UNITED STATES PATENT AND TRADEMARK OFFICE

APPLICATION NO.	FILING DATE	FIRST NAMED INVENTOR	ATTORNEY DOCKET NO.	CONFIRMATION NO.
10/511,861	02/08/2005	Stan Nowak	ASEFF.0101	6378

Office Action Summary

DETAILED ACTION

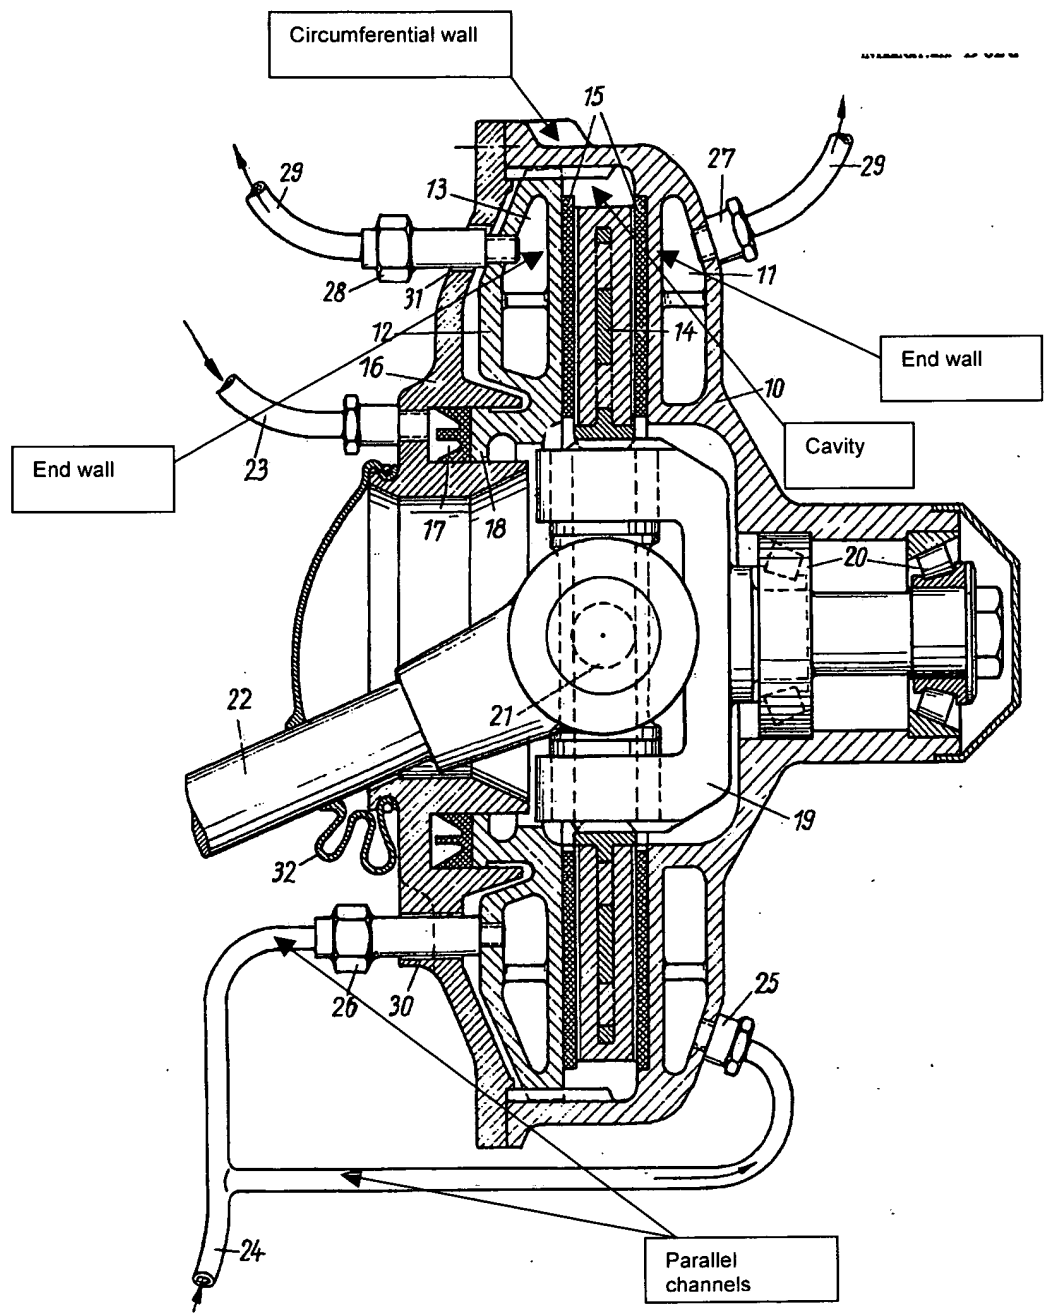
Re: claims 1-3, 15, 16, and 20. DE'319 shows in the figure a fluid cooled brake housing 10 for a brake system that includes friction pads 15 and a rotatable element 14 to be braked, the brake housing comprising a circumferential wall as labeled and two axial end walls as labeled that define a cavity as labeled for housing the friction pads and rotatable element, an opening in the at least one of the axial end walls shown surrounding element 19 through which a portion of the rotatable element can extend, a fluid flow path 13 formed around the periphery (the inner periphery) of the circumferential wall such that the fluid flow path is external to the defined cavity as shown, a fluid inlet 24 in fluid communication with the fluid flow path, a fluid outlet 29 in fluid communication with the fluid flow path, a supply of cooling fluid connected to element 24 in fluid communication with the fluid inlet and the fluid outlet, the cooling fluid flowing from the fluid inlet through the fluid flow path to the fluid outlet thereby cooling the entire brake housing, and a seal means 17,32 for sealing the opening such

that the cavity can be at least partially filled with a volume of lubricating fluid 23 to provide a wet brake housing.

Re: claim 17. DE'319 shows in the figure the limitation wherein the fluid flow path includes a plurality of parallel channels as labeled in the annotated figure on pg. 3 of the instant Office action extending between the fluid inlet and the fluid outlet.

Applicant argues that DE'319 does not anticipate claim 1 because it fails to include the fluid flow path "in the circumferential wall external to the cavity of the housing" as discussed in lines 9-10 of pg. 11 of the Remarks. Examiner notes that the argument is more specific than the claim language. Examiner notes that claim 1 does not require that the fluid flow path be "in the circumferential wall." Instead, claim 1 requires that the fluid flow path be "formed around the periphery of the circumferential wall." Examiner notes that the fluid flow path 13 of DE'319 accommodated in an annular jacket is formed around the periphery and, particularly, the inner periphery of the circumferential wall labeled on pg. 3 of the Office action. Examiner notes that the

Examiner further notes that the bottom surface of the circumferential wall may be considered as one of the outward bounds of the wall. The fluid path 13 being annular in configuration extends along the entire inner periphery of the circumferential wall.

Therefore, Examiner maintains that the fluid flow path is formed around the periphery of the circumferential wall. With regards to the fluid flow path being external to the cavity, Examiner maintains that the cavity has been redefined as set forth in the annotated drawing on pg. 3. In light of the newly interpreted location of the cavity, it is apparent that the fluid flow path is external to the cavity.

Applicant then argues that DE'319 does not anticipate claim 1 or claim 20 because it does not show a seal means for sealing the opening of the cavity in order to create a wet brake system. Examiner notes that the opening is shown surrounding element 19. Elements 17 and 32 clearly seal or block the passage of fluid from and into the area surrounding element 19. The claim recites the wet brake limitation in functional terms. Since the seal means 17,32 blocks fluid passage, Examiner maintains that the seal means of DE'319 is capable of sealing such that the cavity can be partially filled with lubricating fluid to provide a wet brake housing. Examiner also notes that the argument that since the prior art of DE'319 teaches the use of a wet brake system, it is doubtful that DE'319 would seek to teach a similar wet brake is not persuasive. First, Applicant's doubt that DE'319 would not teach a wet brake is purely speculative. Second, it does not matter whether DE'319 actually teaches a wet brake since claim 1 merely requires that the seal means be capable of sealing to provide a wet brake.
